AGENDA – Planning Commission Meeting

PLANNING COMMISSION Staff Report

Rezone, General Plan Amendment, and Concept Plan

Alpine School District High School 722

Exhibit 5. Concept Site Plan

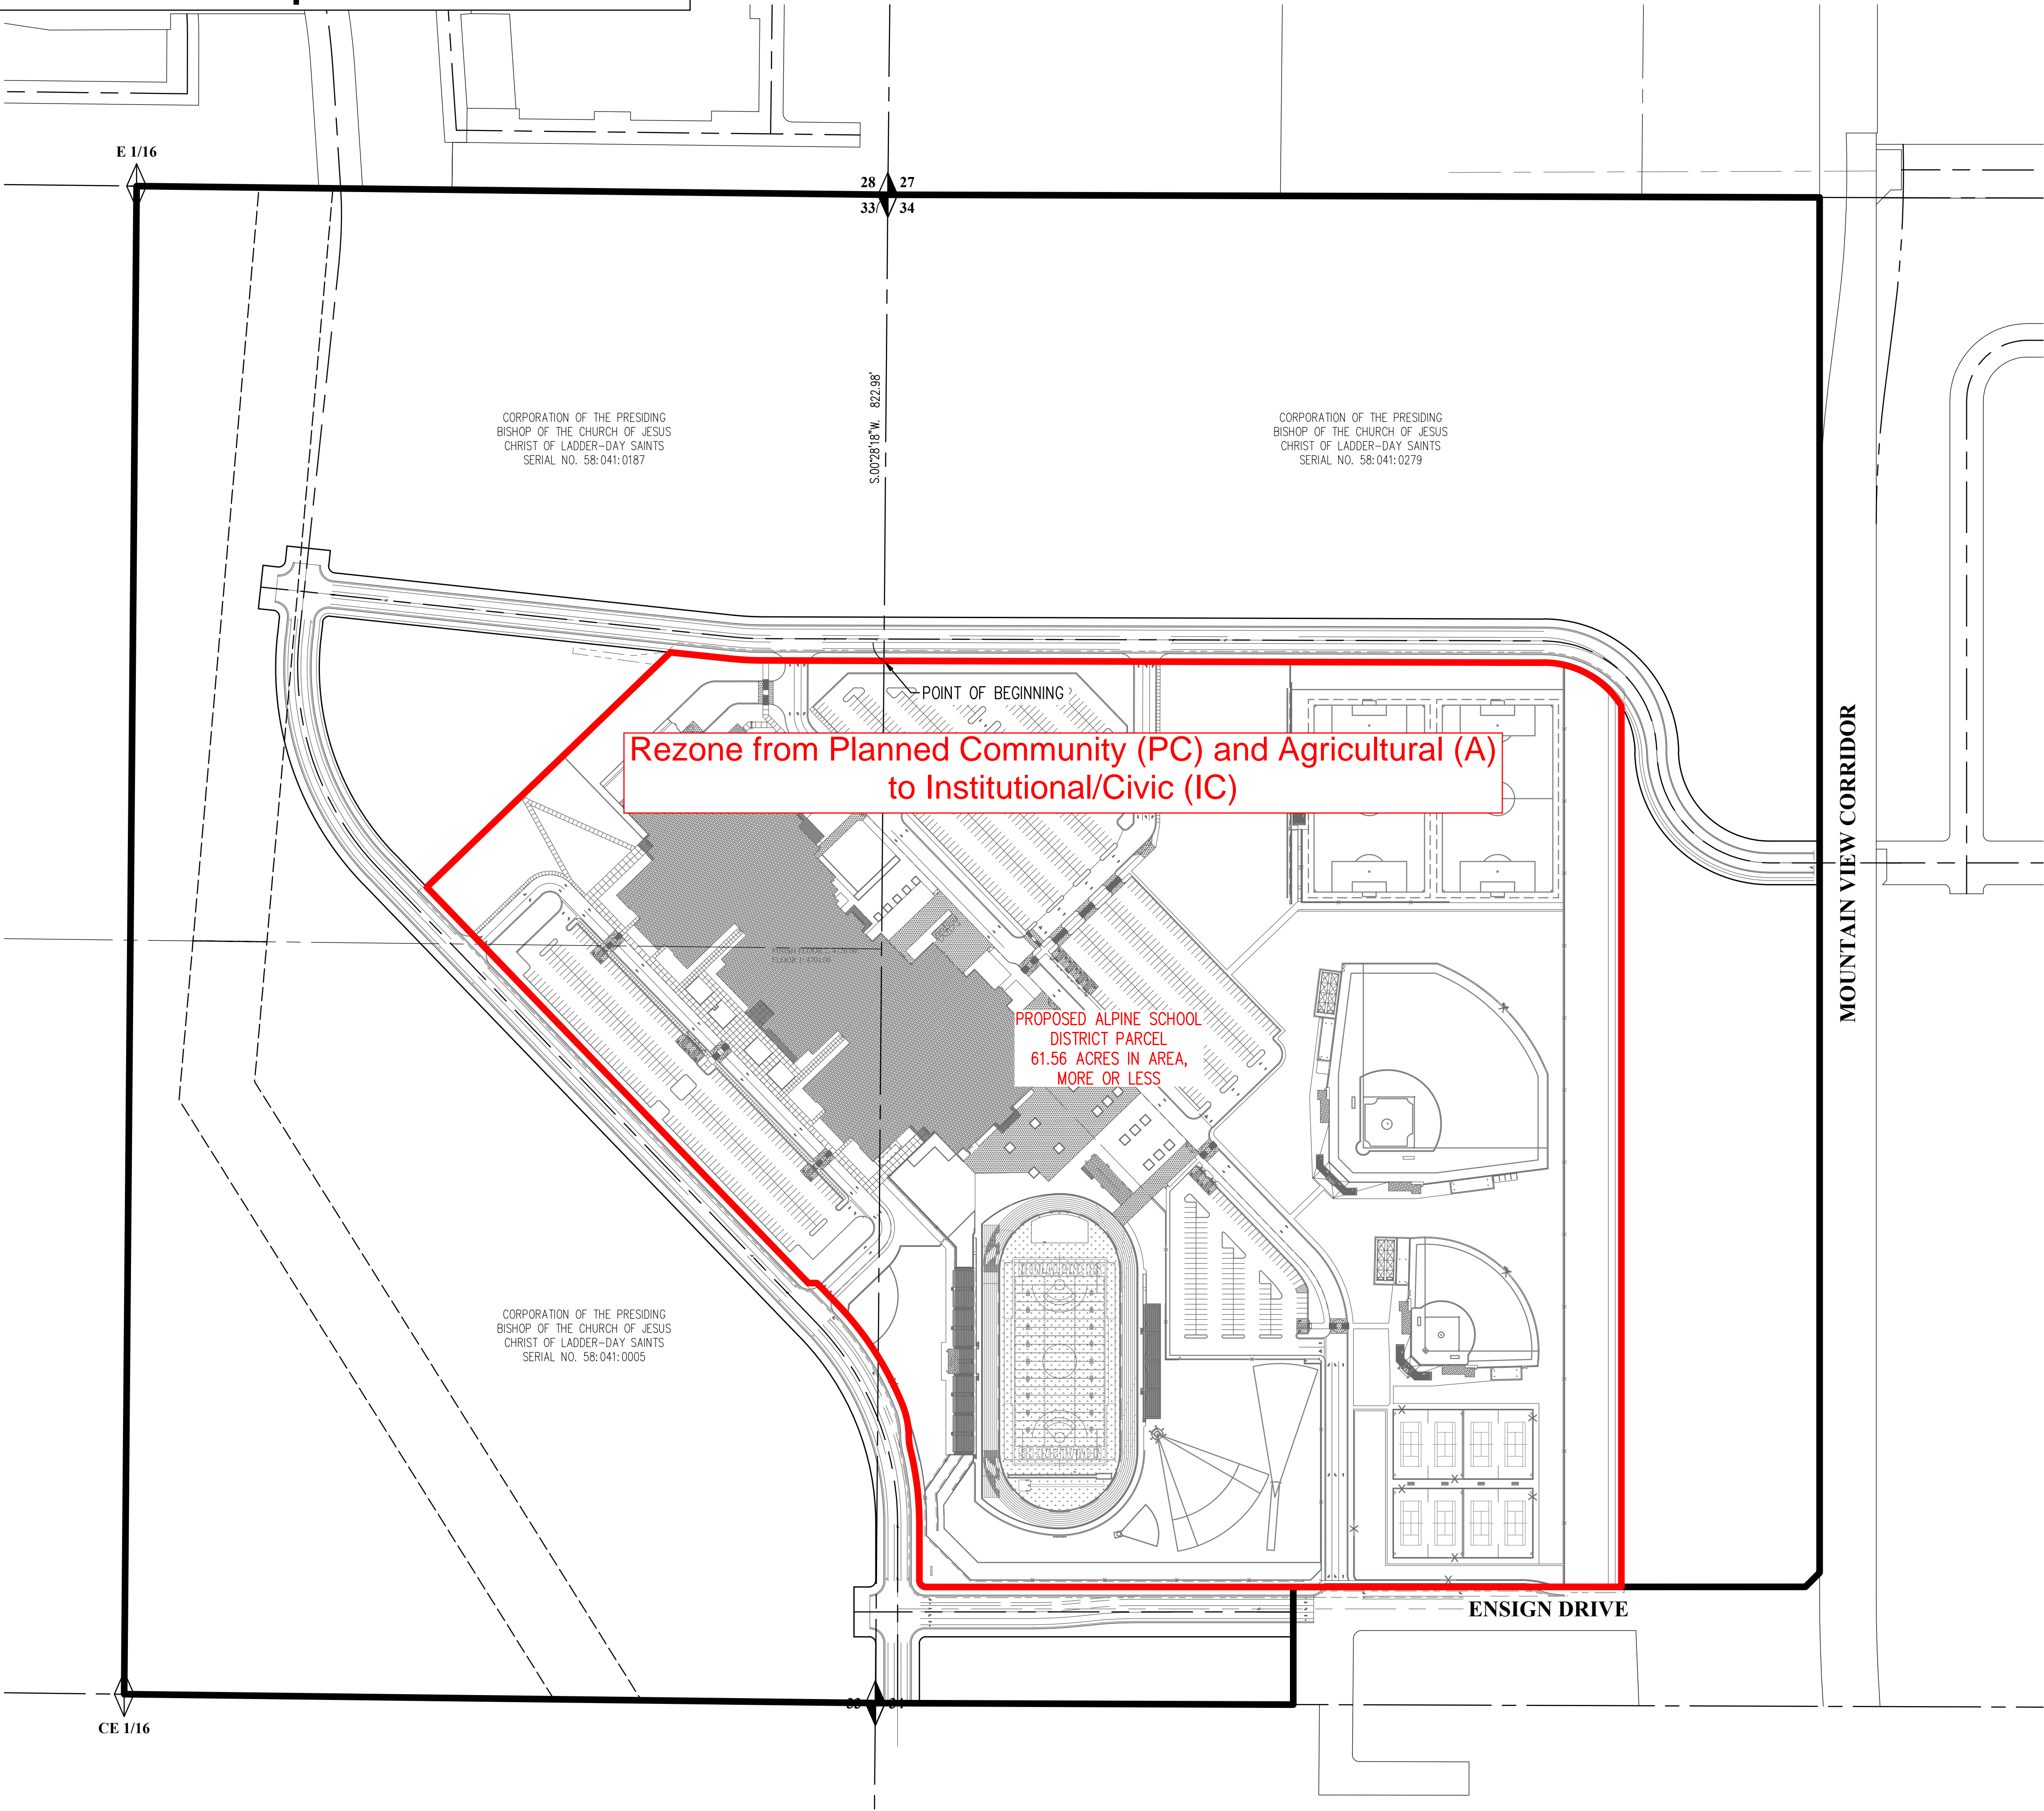
Staff Finding: **Shall Comply.** Due to the need for the High School to serve both Eagle Mountain and Saratoga Springs, the attached Engineer's Staff Report requires that Bonneville Drive in Saratoga Springs be extended to the north to connect with Silver Lake Parkway in Eagle Mountain in order to provide logical vehicular and pedestrian connections for future students. This connection is shown in the 2025 Transportation Master Plan.

- i. Project shall comply with the City's current adopted Transportation Masterplan.
- ii. In accordance with the City's Transportation Master Plan, Ensign Drive shall be built and extended as a minor arterial roadway along the south of the site including the intersection of Ensign Drive and Bonneville Drive.

- iii. In accordance with the City's Transportation Master Plan, Bonneville Drive shall be built and extended as a collector road along the west side of the project. This road shall extend south through the intersection of Ensign Drive to the south connecting to the existing portion of Bonneville Drive within Brixton Park Plat B Phase 2 and north to the municipal boundary with Eagle Mountain connecting to the existing Silverlake Pkwy.

- i. Project shall comply with the City's current Drinking Water and Pressurized Irrigation Master Plans
- ii. A Zone 2 16" drinking water line and 20" Pressurized Irrigation Line shall be installed in Bonneville Drive connection the existing master planned Pipes in the Brixton Park Plat B Phase 2 plat and extending North to the future intersection of Halverson and Bonneville Pkwy.
- iii. A 20" pressure irrigation line should be installed in the Bonneville Drive Right-of-Way.
- iv. The increased demand from the development causes pressure in the irrigation system to drop below the level of service in the Brixton Park development. The master planned Zone 2 South irrigation pond (Pond 12) must be constructed before the development connects to the

- v. There is a master planned pressurized irrigation storage facility near the development (Pond 5). The location of this facility is preliminary. It is recommended that the location of this pond be solidified before proceeding with the development.
- vi. The project concept plan currently shows water line dead-end pipelines longer than 600 feet on the drinking water system, this is not in compliance with the City's engineering standards and specification and needs to be corrected.

- i. Project shall comply with the City's current adopted Stormwater Masterplan.
- ii. This stormwater release rate for this site is determined by the Tickville Outfall's downstream capacity. All stormwater shall be detained and treated in accordance with City Standards and then may be discharged to the City system at a rate not to exceed 0.016 cfs/acre. If there is insufficient capacity in the existing system, a new outfall to Tickville Wash may be required. New crossings of MVC will not be permitted.

- i. Project shall comply with the City's current adopted Sanitary Sewer Masterplan.
- ii. Project shall connect to the City Existing system at either Ensign Drive or Halvorsen Parkway. New crossings of MVC will not be permitted.
